stm32-blinky — Design Document

Board review: stm32-blinky (P8 adversarial pass)

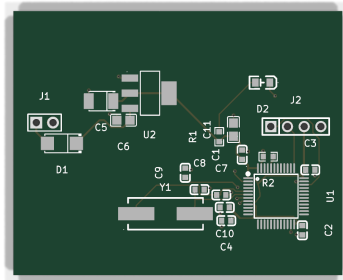
W1 (reviewer warning 4, issue 4): "erc-pintypes-vacuous" - easyeda2kicad symbols carry mostly-passive pin types even after datasheet-driven retyping of supplies, so ERC's driver-conflict/float checks have reduced power on this board. Waived: connectivity was independently hand-verified by the adversarial reviewer against both datasheet extracts (all 9 supply pins, polarity, strapping). Tooling fix (retype at lib_pull time, GPIOs as bidirectional) queued as S14 hardening item.

Note: reviewer warnings 2 (VDDA 1uF//10nF) and 3 (VDD_3 bulk) were FIXED, not waived, along with error 1 (22uF tantalum LDO output cap) - see state.json issues 1-3 and the second erc gate commit.

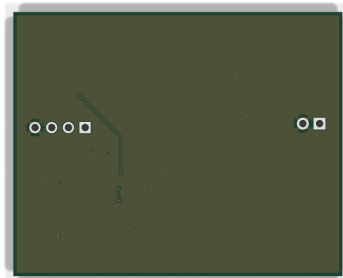
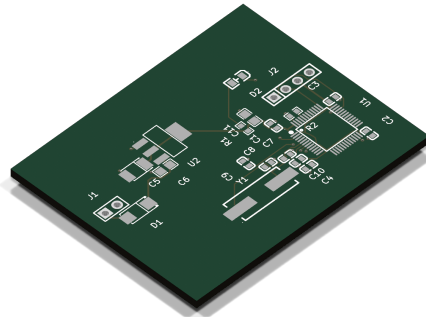
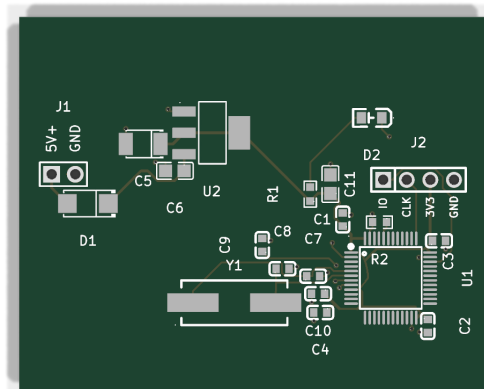
ERROR 1 - J1 power input has no polarity legend on silk (requirements miss)

requirements.md sec 2 and architecture/blocks.md both promise the 5 V input "polarity marked on silkscreen" (J1 pin 1 = +5 V, pin 2 = GND). The as-built board has NO text or +/- legend anywhere: silk carries refdes only (there is not a single gr_text on the board). What exists at J1 is a pin-1 dot and a square pad (see crop-j1_d1.png) - and the dot sits on the header body outline,

so after the header is soldered the plastic covers it. Post assembly the top side shows nothing but "J1"; the square pad is visible only from the bottom.

Consequence: the unkeyed 2-pin input can be plugged backwards with no on-board hint. D1 (series SS34) prevents damage - reversed input just does not conduct - but the user gets a dead board and no way to know why or which way is right without opening the design files. This is the board's primary human interface and an explicit requirements promise. Fix is two silk texts ("5V", "GND" or "+", "-") next to the holes, outside the header body. Must fix before fab; there is ample empty silk area (left region is empty).

WARNING 1 - J2 SWD pins unlabeled (architecture promise miss)

`blocks.md` promises "Canonical pin order (silk-labeled): 1 = SWDIO, 2 = SWCLK, 3 = 3V3, 4 = GND". Electrical order verified correct from the netlist (pads: SWDIO/SWCLK/+3V3/GND, U1 PA13/PA14 to pins 1/2). But there are no labels - only a pin-1 square cell (`crop_d2_j2.png`) which the header body covers after assembly. ST-Link clones are wired pin-by-pin; swapping 3V3/GND shorts the debugger's 3.3 V rail to ground. Same trivial fix as ERROR 1 (four small silk texts below the header row - the area under J2 is clear). Strongly recommend fixing together with ERROR 1; warning rather than error only because `requirements.md` itself demands the ORDER (met), the labels are an architecture-level promise.

WARNING 2 - refdes association ambiguity (cap cluster + C3-under-J2)

- "C11" text sits directly above R1's body; "C1" text below-left of R1; "C7"/"C8" labels float between parts they do not touch. Among these 0603s are four DIFFERENT cap values (22 pF, 10 nF, 100 nF, 1 uF) plus a 1 k resistor - a hand-rework or debug probe guided by silk has a real chance of landing on the wrong part.
- "C3" text renders directly under J2 pads 3-4 and reads like a header label (its own body is 3.6 mm away). Mildly reinforces the J2 labeling problem: someone may read "C3" while counting SWD pins.
